MEMORANDUM

To: Ms. Rebecca Chu, EPA
From: Ryan Barth, P.E., Anchor QEA, LLC
Amy Essig Desai, Farallon Consulting, LLC
Cc: Gil Leon, Earle M. Jorgensen Company
Miles Dyer, Jorgensen Forge Corporation
Bill Joyce and Ian Sutton, Joyce Ziker
Parkinson, PLLC
Jeff Kray, Marten Law
Chris Schraff, Porter Wright
Ravi Sanga, EPA
Holly Arrigoni, EPA
Maureen Sanchez, Ecology
Will Ernst, The Boeing Company
Tom Colligan, Floyd Snider
Philip Spadaro, The Intelligence Group
Re: Jorgensen Forge Early Action Area Removal Action
Addendum to the Final Basis of Design Report
Administrative Order on Consent, EPA Docket No. CERCLA 10-2013-0032

REVISED BODR FIGURES

Figure 8c
JFOS Impacted Material Area Cross-Sections
Basis of Design Report
Jorgensen Forge Early Action Area

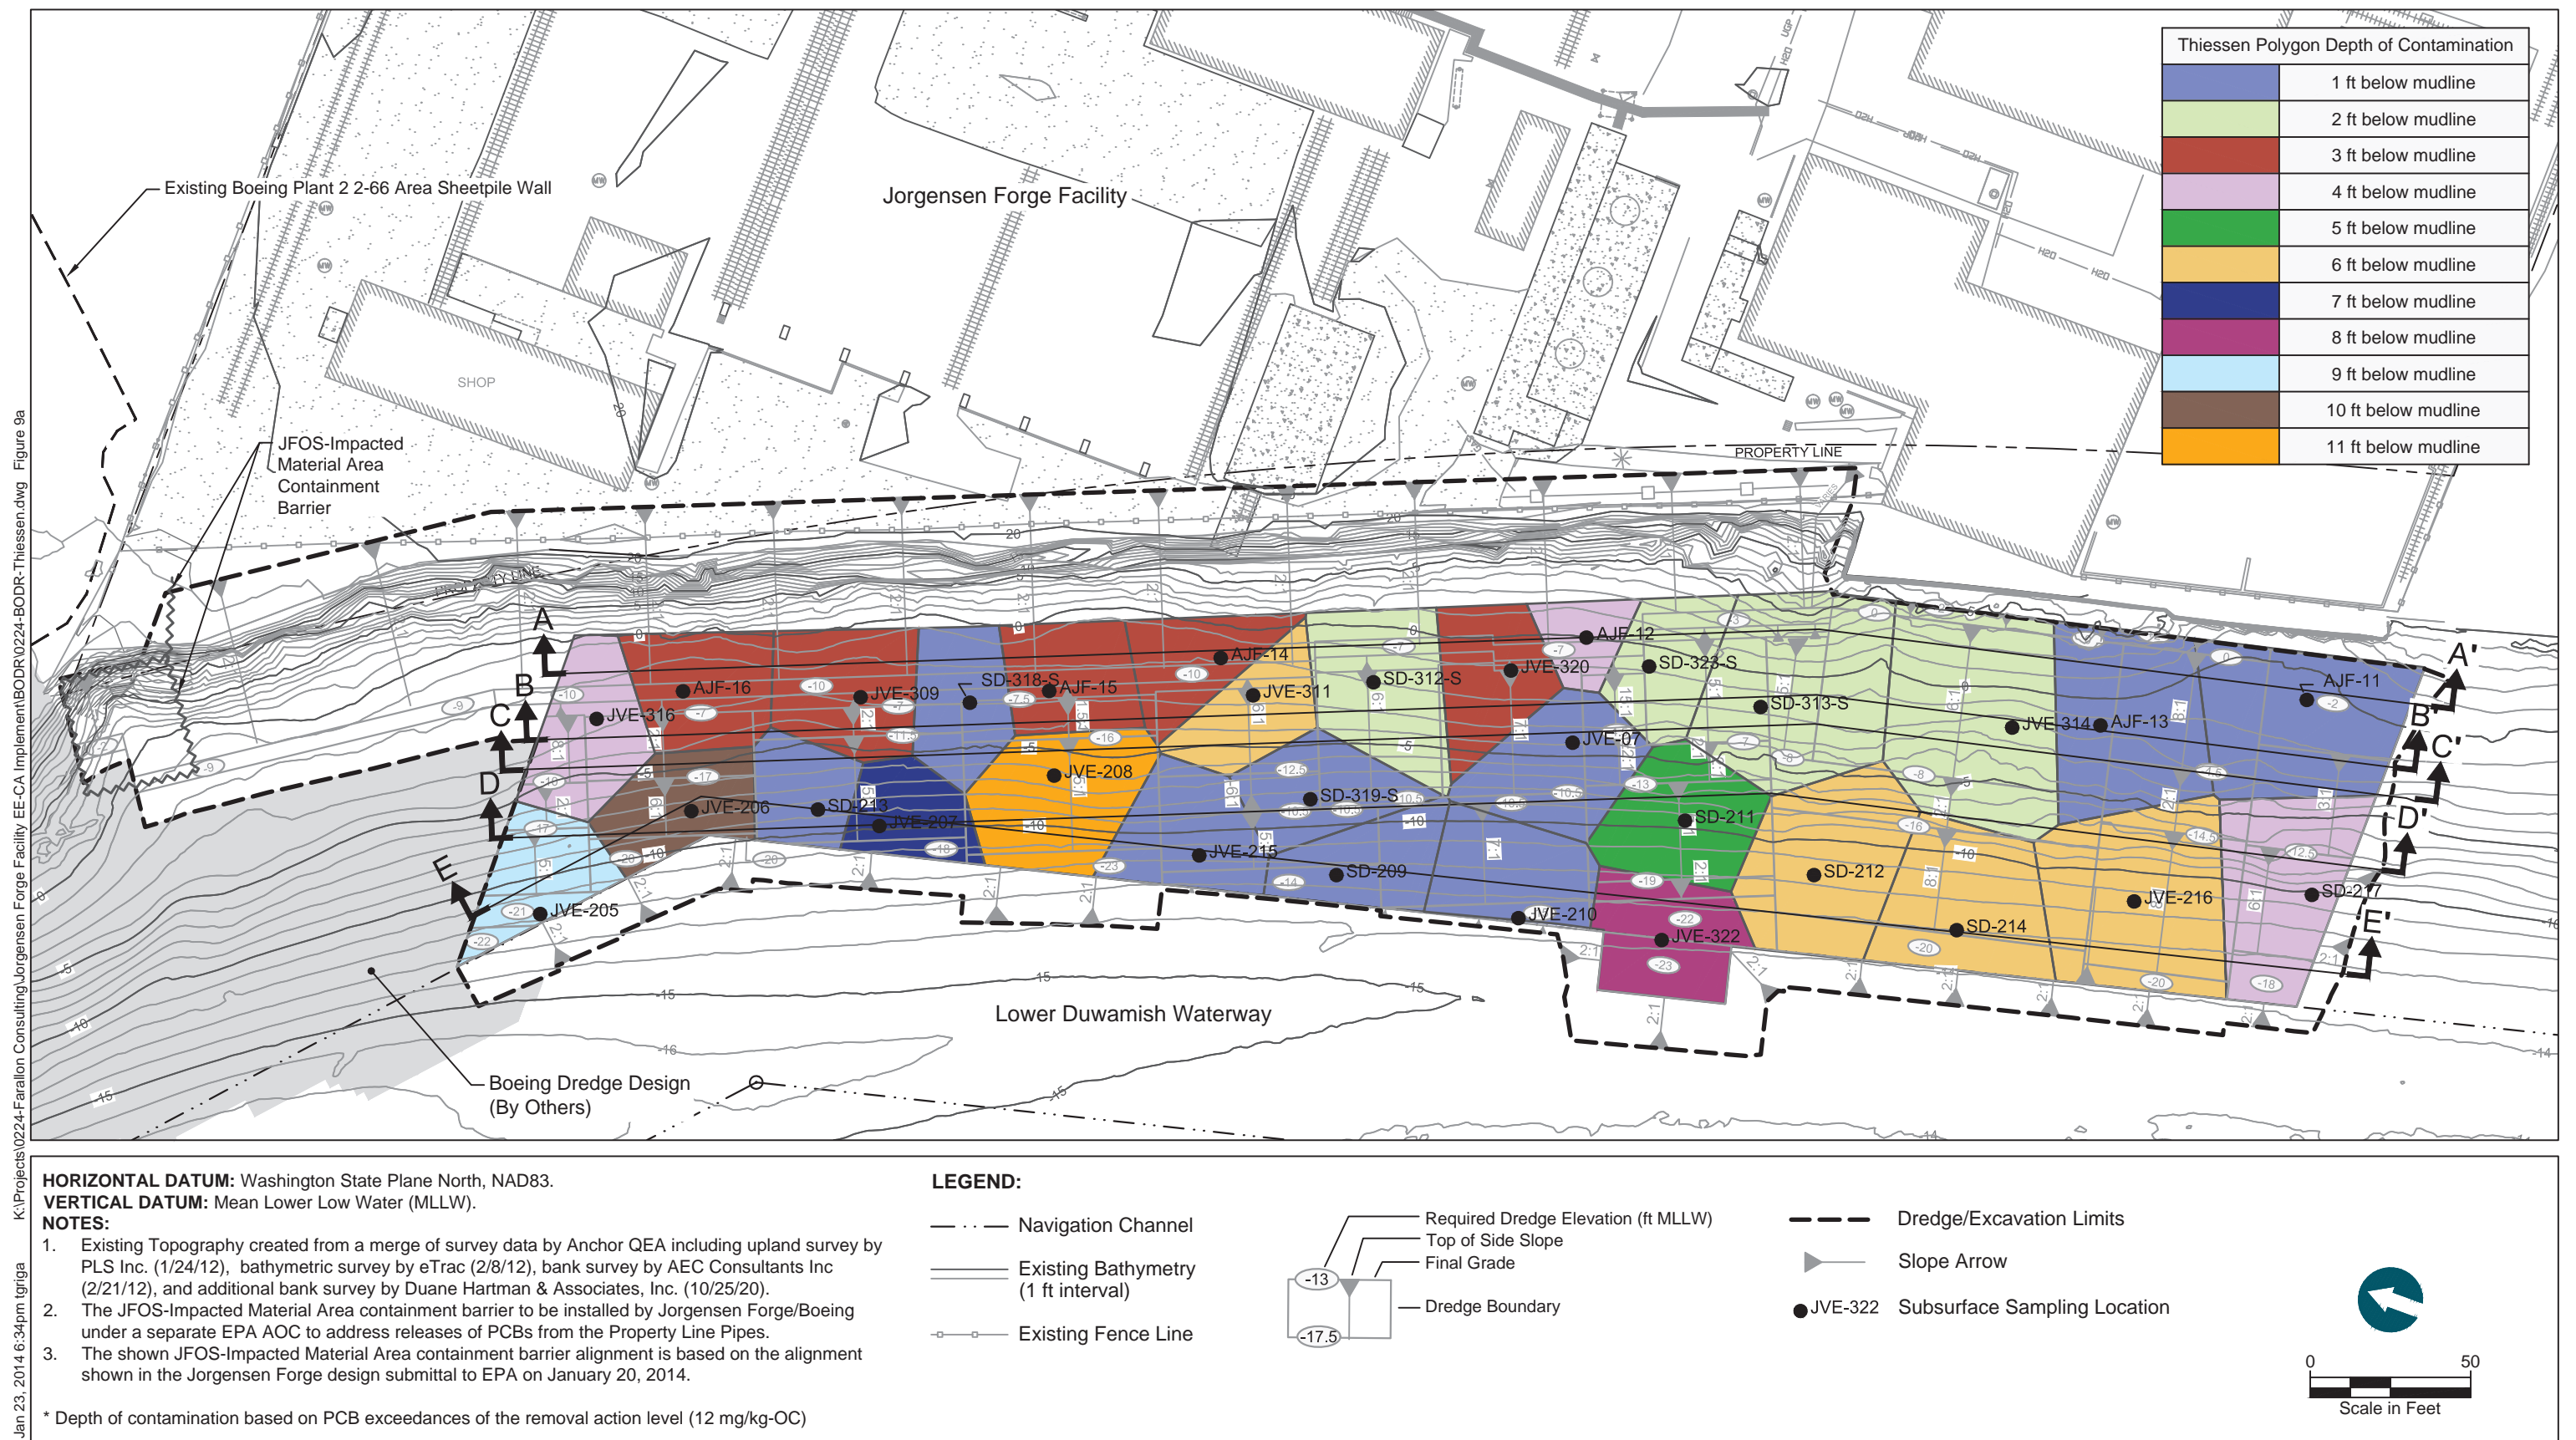
to EPA on December 19, 2013 did not include the in-water containment barrier wall alignment. Figures 8a, 8b, and 8c in Attachment 1 show the revised dredge prism within the in-water containment barrier wall alignment. The EMJ Removal Action Construction Specifications have been revised to reflect the revised dredge design, revised contractor bids for removal within the in-water containment barrier have been received, and EMJ is currently finalizing contractor selection.
